Kentucky Transportation Cabinet Value Engineering Study Mountain Parkway Corridor – Construction Sequence 4

Item #10-168.00, Wolfe County

Final Value Engineering Study Report

Study Dates: March 9-13, 2015

TITLE: Use retaining wall at KY 1419 (Sta 617+00 to 620+00) to eliminate part of the reconstruction

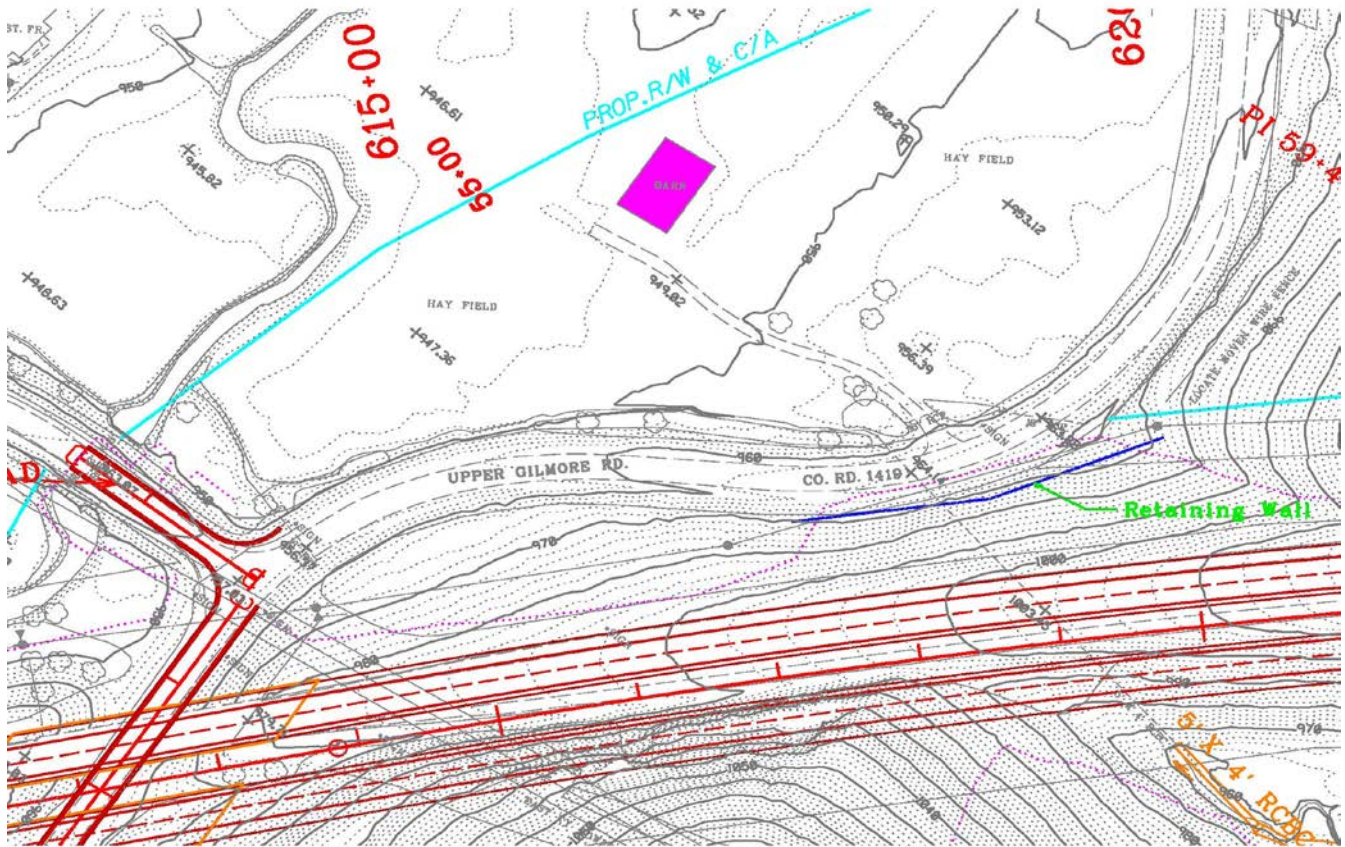
The retaining wall would have to be placed over an existing 5-foot x 4 foot RCBC. The relocation of KY 1419 is in fill so this area provides an additional waste area which is an advantage that is not associated with a cost.

TITLE: Use barrier wall in lieu of 40-foot median the entire length of the project

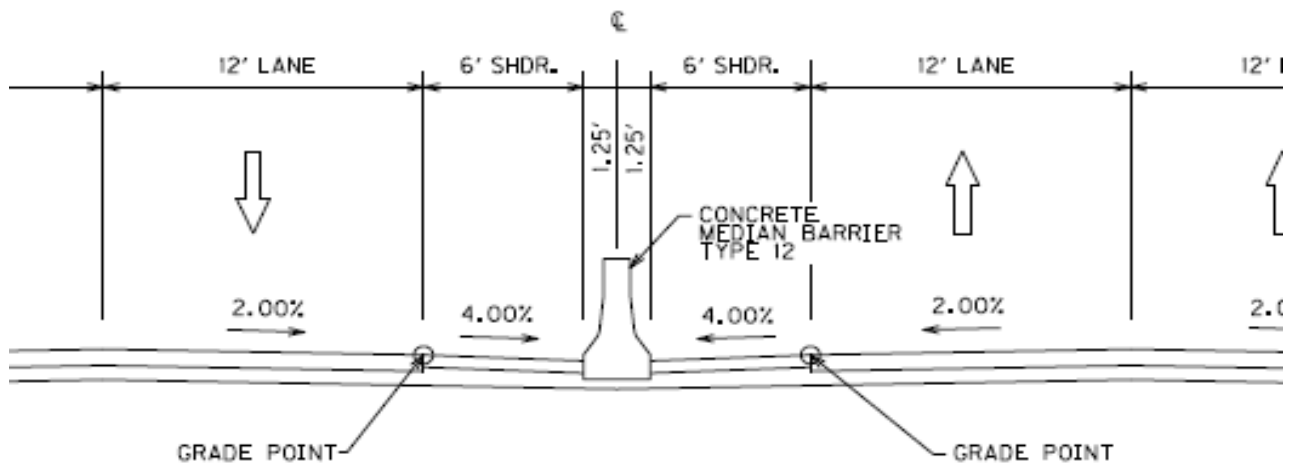
Roadway excavation is the largest cost item on project. As a means to reduce the volume of excavation on the project, this alternative recommends using concrete median wall throughout corridor in lieu of the proposed 40-foot depressed median. This change would reduce the width of roadway, which will result in less excavation, along with a decrease in overall disturbance footprint.

TITLE: Straighten KY 1419 on the south side to reduce the skew

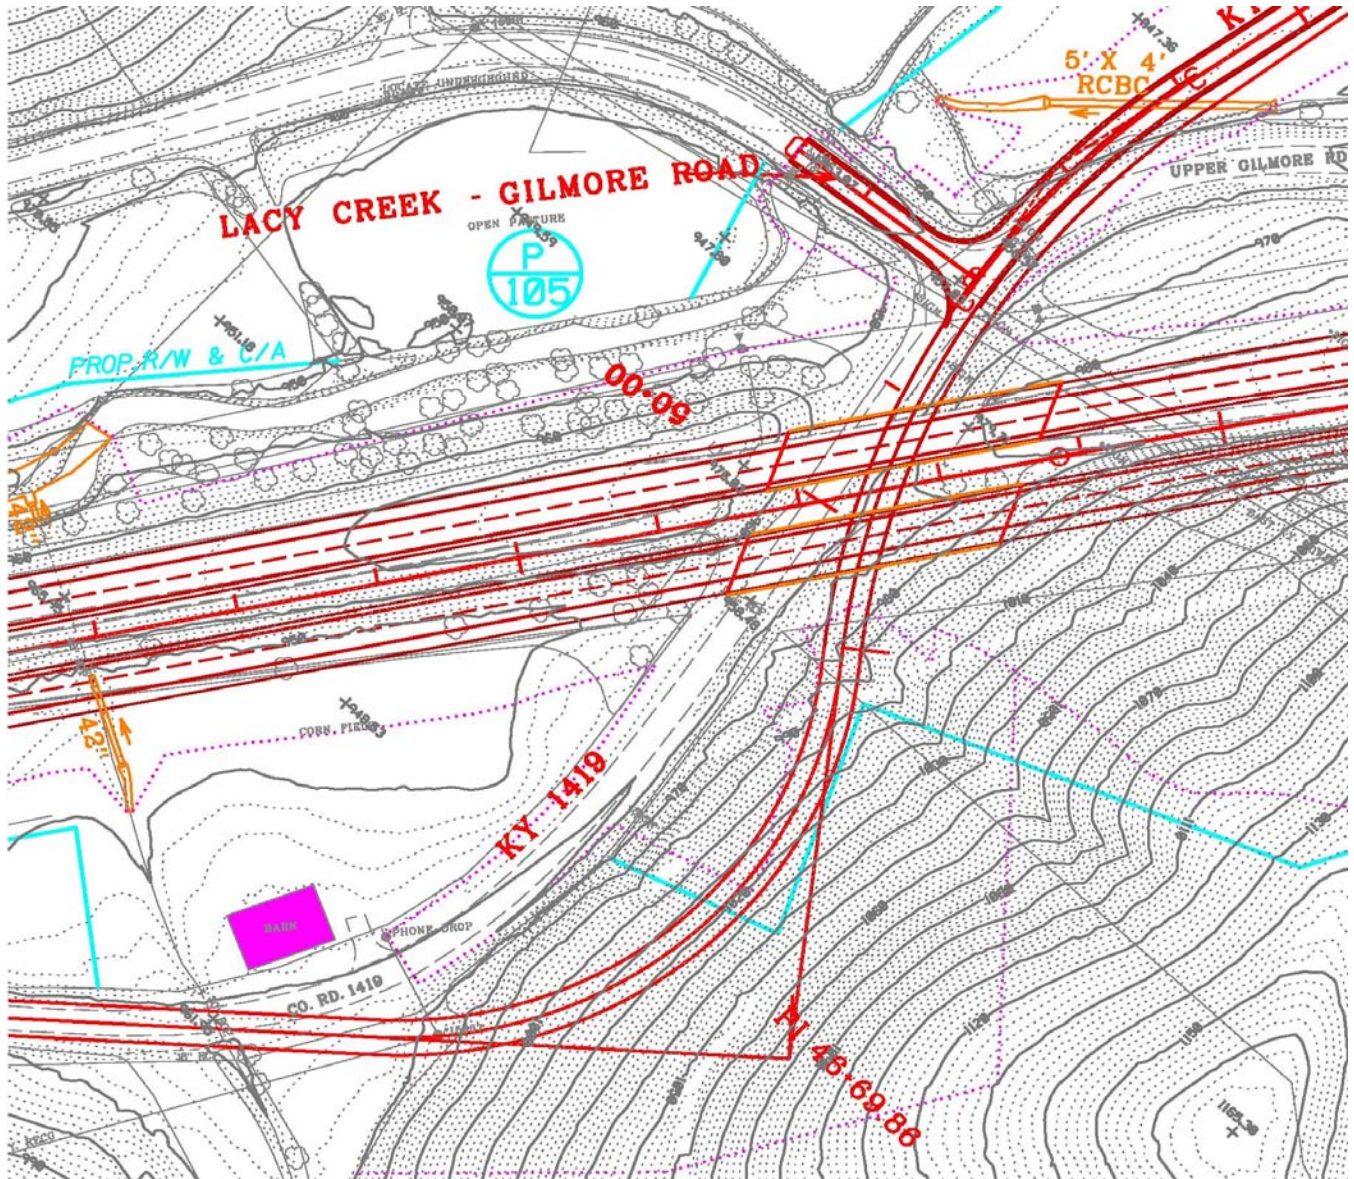
This alternative proposes to straighten the bridge to provide a cost savings with the bridge. The bridge savings is estimated at approximately \$250,000 however, the costs of excavating the hillside right of centerline (\$1.1 million) exceeds the savings of a shorter bridge. **No further consideration of this alternative is recommended due to the increase in cost with no improvement to project function.**

TITLE: Relocate KY 1419 to STA 620+00 and cross over the mainline

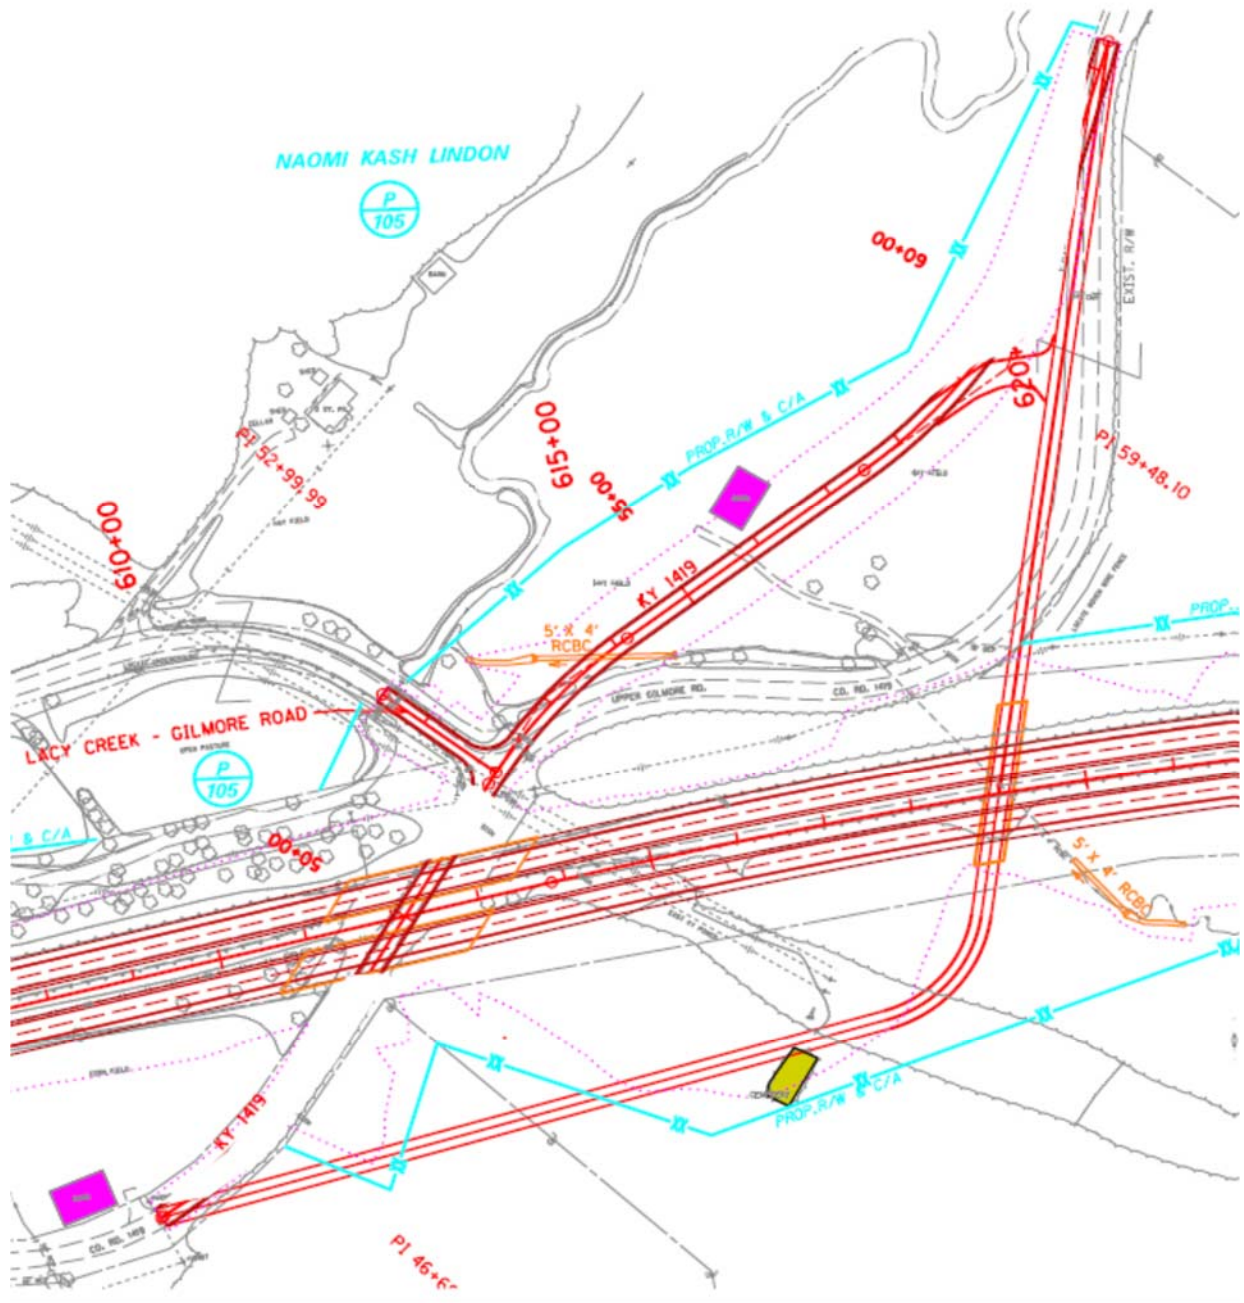
After a more detailed review, the Value Engineering team does not recommend this alternative as the estimated costs related to this alternative indicate there would be no savings, primarily due to the relatively large increase in excavation volume for KY 1419. Also, the horizontal and vertical alignments required for KY 1419 to cross over the parkway would not be as desirable as the baseline approach. The alternative alignment would only meet approximately a 25 mph design speed. This alternative would also require a steep tie-in for Lacy Creek-Gilmore Road.

TITLE: Bifurcate the roadway from Sta 536+00 to Sta 544+00

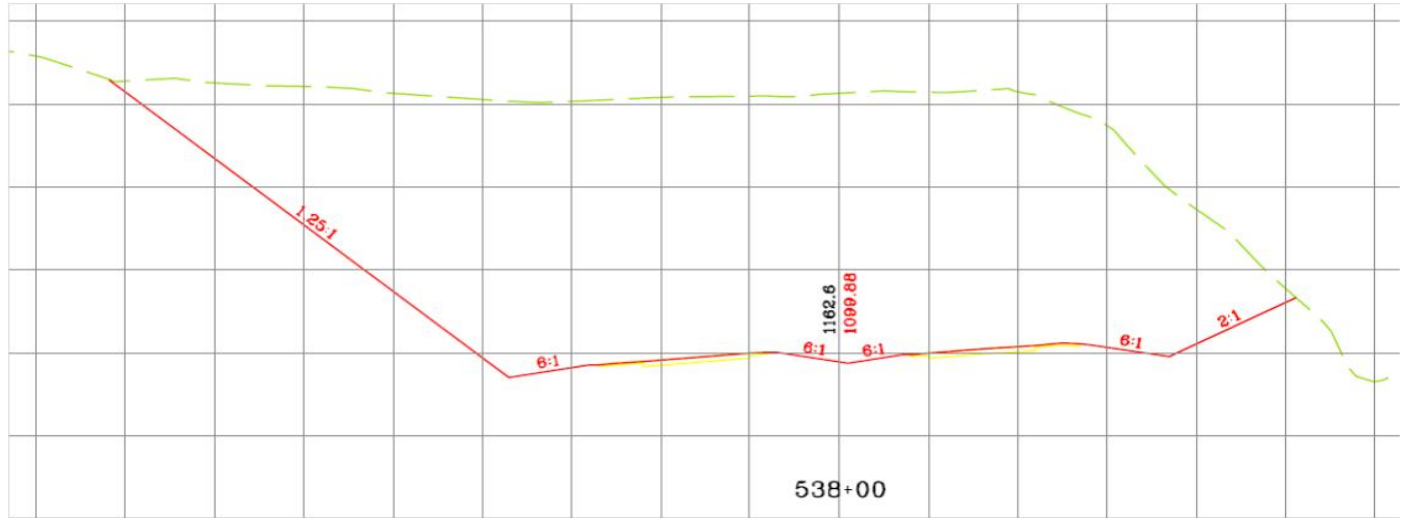
TITLE: Bifurcate the roadway from Sta 536+00 to Sta 544+00			
FUNCTION: Convey Vehicles			
BASELINE ASSUMPTION: The current design shows the east bound and west bound lanes at the same elevation along centerline throughout the entire corridor.			
PROPOSED ALTERNATIVE: The proposed alternate would reduce the cross-sectional width of the roadway through the cut sections. The elevations for the lanes nearest the cut will be raised by approximate 15 feet. The grade change will be transitioned on each side of the cut.			
BENEFITS		RISKS/CHALLENGES	
<ul style="list-style-type: none"> Reduces quantity of excavation 		<ul style="list-style-type: none"> Depending upon the durability of the rock. The high wall could erode, compromising the roadway section above 	
<ul style="list-style-type: none"> Reduces construction time, due to reduction in roadway excavation quantities 		<ul style="list-style-type: none"> The elevated lanes could shade the lower lanes, creating a cold spot in the winter

The current plans call for 5.915 million cubic yards of roadway excavation for this eleven mile section of the Mountain Parkway. The proposed alternate reduces the cross-sectional width of the roadway through the cut sections, thus reducing the roadway excavation quantity. The travel lanes closest to the cut will be raised approximate 15 feet. The grade changes will be transitioned on the back station and ahead station ends of the cut. This will require installation of guardrail with end treatments.

TITLE: Bifurcate the roadway from Sta 176+00 to Sta 197+00

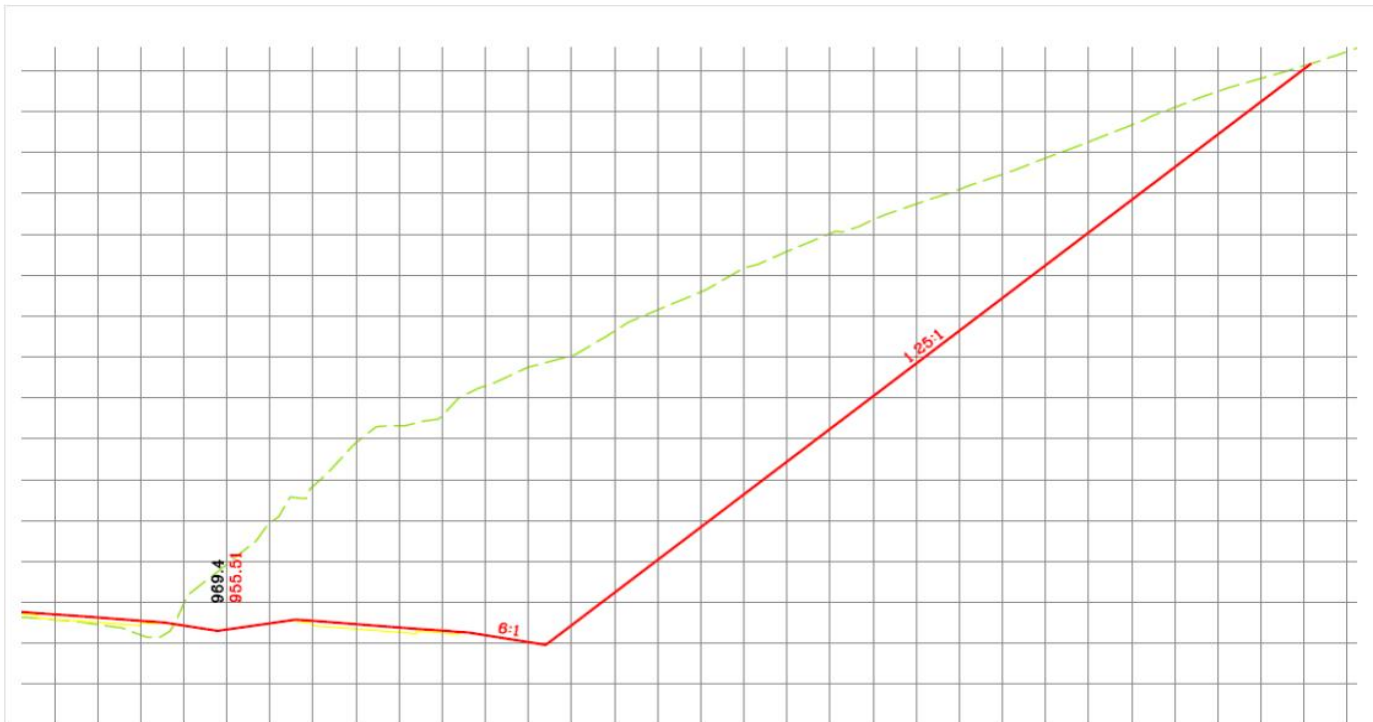
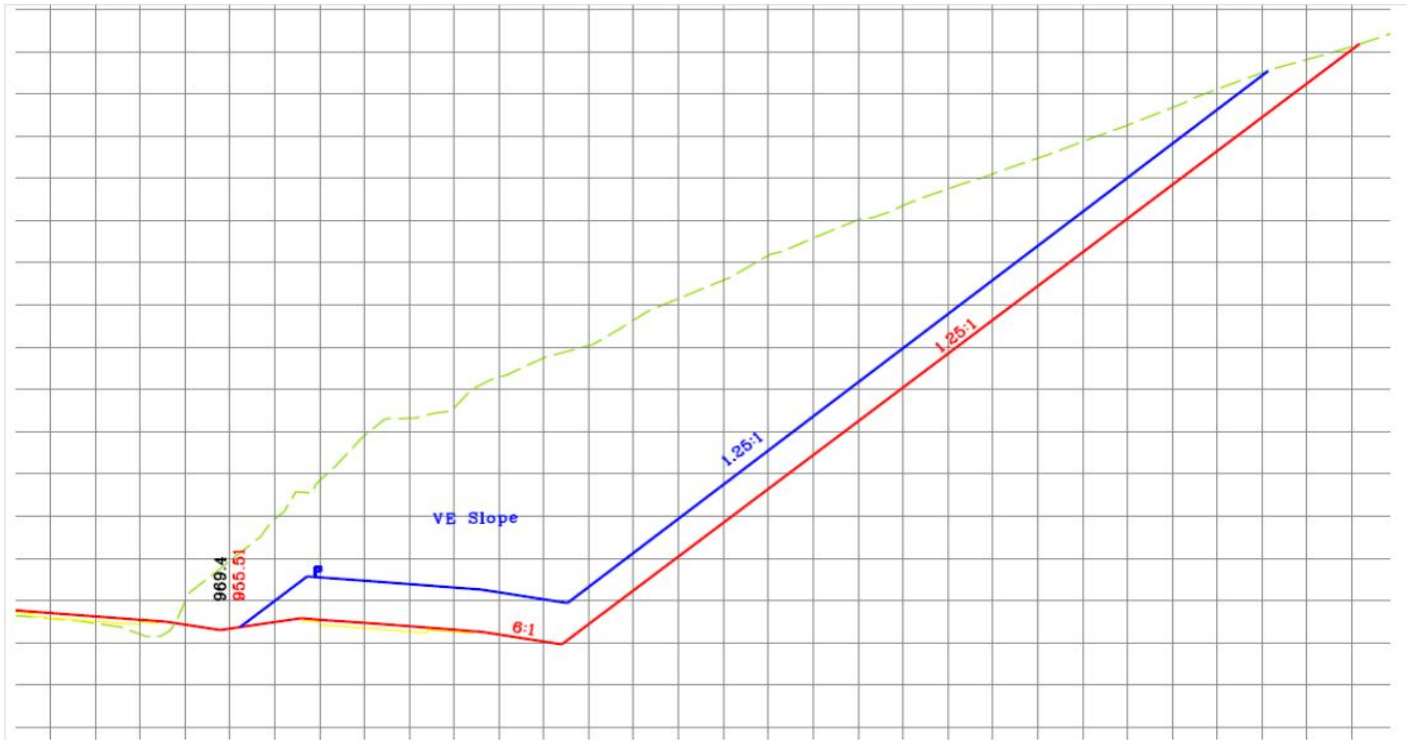
TITLE: Bifurcate the roadway from Sta 176+00 to Sta 197+00																							
FUNCTION: Convey Vehicles																							
BASELINE ASSUMPTION: The current design shows the east bound and west bound lanes at the same elevation along centerline throughout the entire corridor.																							
PROPOSED ALTERNATIVE: The proposed alternative would reduce the cross-sectional width of the roadway through the cut sections. The elevations for the lanes nearest the cut will be raised by approximately 10 feet. The grade change will be transitioned on each side of the cut.																							
BENEFITS		RISKS/CHALLENGES																					
<ul style="list-style-type: none"> Reduces quantity of excavation 		<ul style="list-style-type: none"> Requires installation of guardrail with end treatments 																					
<ul style="list-style-type: none"> Reduces construction time, due to reduction in roadway excavation quantities 		<ul style="list-style-type: none"> Depending upon the durability of the rock. The high wall could erode, compromising the roadway section above 																					
<ul style="list-style-type: none"> 		<ul style="list-style-type: none"> The elevated lanes could shade the lower lanes, creating a cold spot in the winter 																					
<ul style="list-style-type: none"> 		<ul style="list-style-type: none"> The bench width required for elevated lanes could be compromised, due to fallouts or improper blasting practices 																					
<ul style="list-style-type: none"> 		<ul style="list-style-type: none"> 																					
<ul style="list-style-type: none"> 		<ul style="list-style-type: none"> 																					
<ul style="list-style-type: none"> 		<ul style="list-style-type: none"> 																					
<ul style="list-style-type: none"> 		<ul style="list-style-type: none">

The current plans call for 5.915 million cubic yards of roadway excavation for this eleven mile section of the Mountain Parkway. The proposed alternative reduces the cross-sectional width of the roadway through the cut sections, thus reducing the roadway excavation quantity. The travel lanes closest to the cut will be raised approximately 10 feet. The grade changes will be transitioned on the back station and ahead station ends of the cut.
